CITY OF AUSTIN – DEVELOPMENT SERVICES DEPARTMENT
SITE PLAN APPLICATION – MASTER COMMENT REPORT

CASE NUMBER: SP-2019-0297C
REVISION #:
CASE MANAGER: Jeremy Siltala

PROJECT NAME: 218 South Lamar
LOCATION: 218 S LAMAR BLVD SB

SUBMITTAL DATE: June 11, 2020
REPORT DUE DATE: June 25, 2020
FINAL REPORT DATE: June 29, 2020 (4 DAYS HAVE BEEN ADDED TO THE UPDATE DEADLINE)

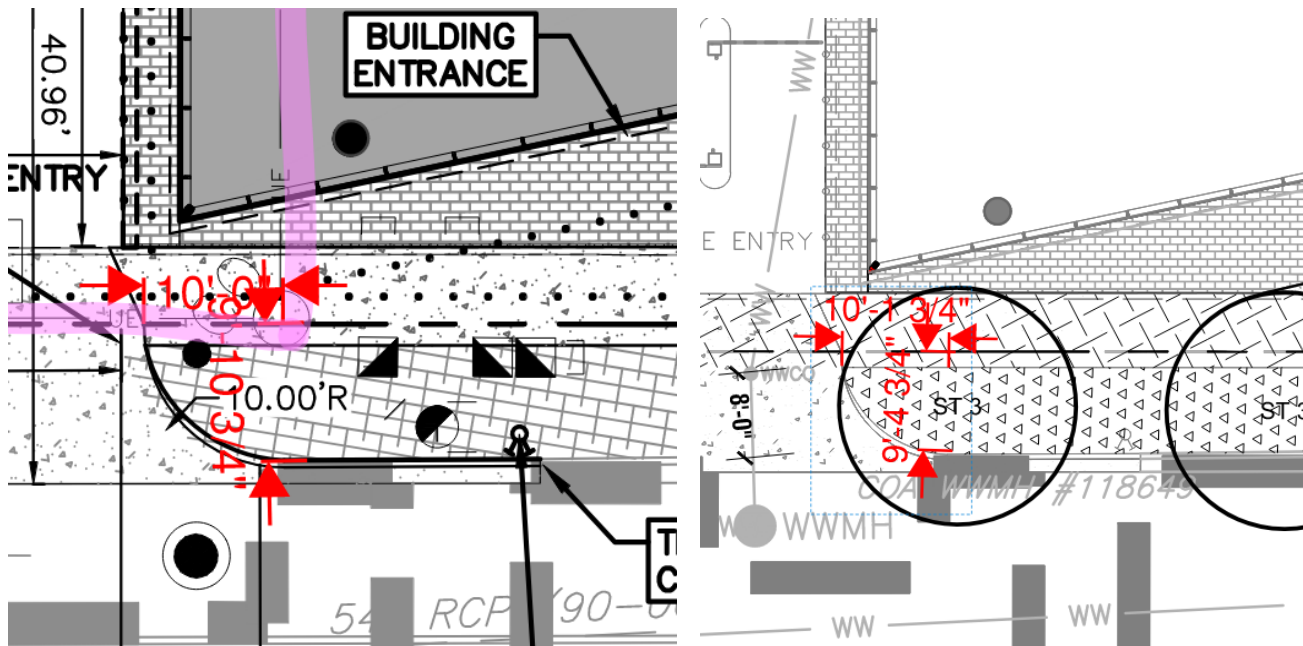
INFORMAL: Street tree on east corner of driveway is in conflict with proposed underground electric facility. Set back at least 10' or change to utility compatible species.

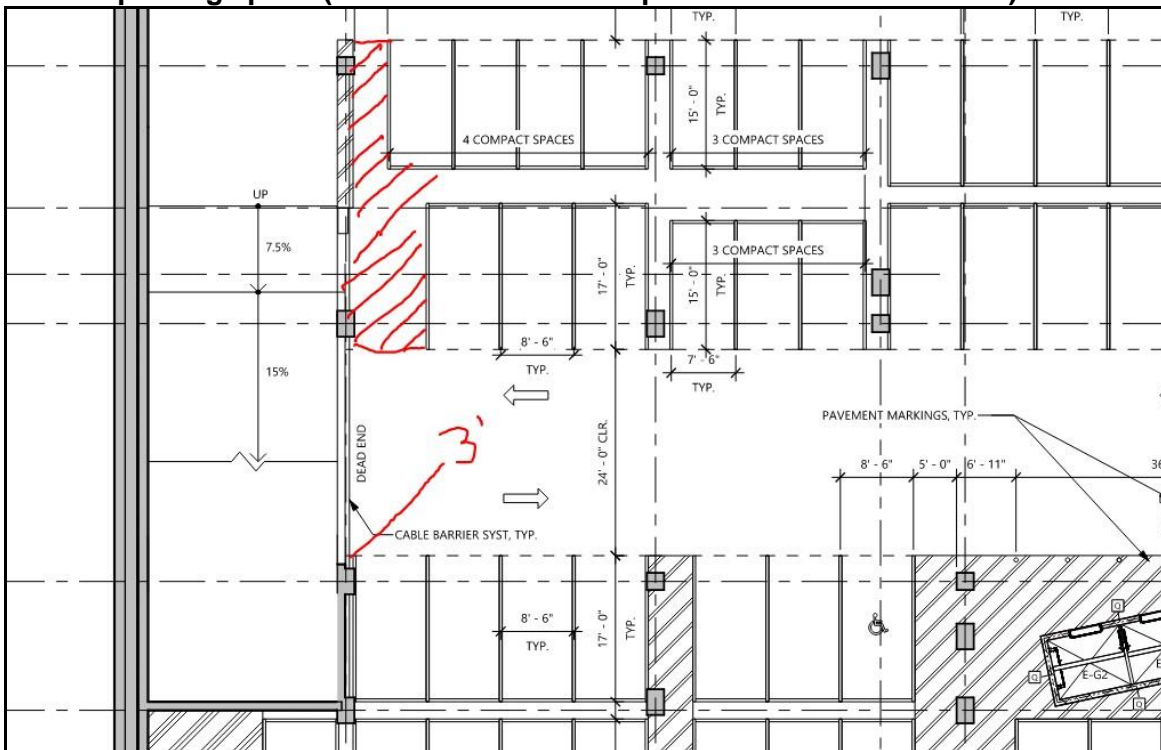
TR52. Each parking space must have adequate drives, aisles, and turning and maneuvering areas for access and usability. TCM, 9.2.0 #5. Show and dimension an additional 3 feet of spacing between the garage wall and the parking spaces at the end of each dead-end drive aisle.

U2: Comment remains. Some parking spaces still lack appropriate maneuvering areas (see image). Please stripe the area shown to clearly indicate whether or not it is a parking space, and provide a 3-foot maneuvering spacing between the wall and the edge of the nearest parking space (so that cars in those spaces are able to back out).
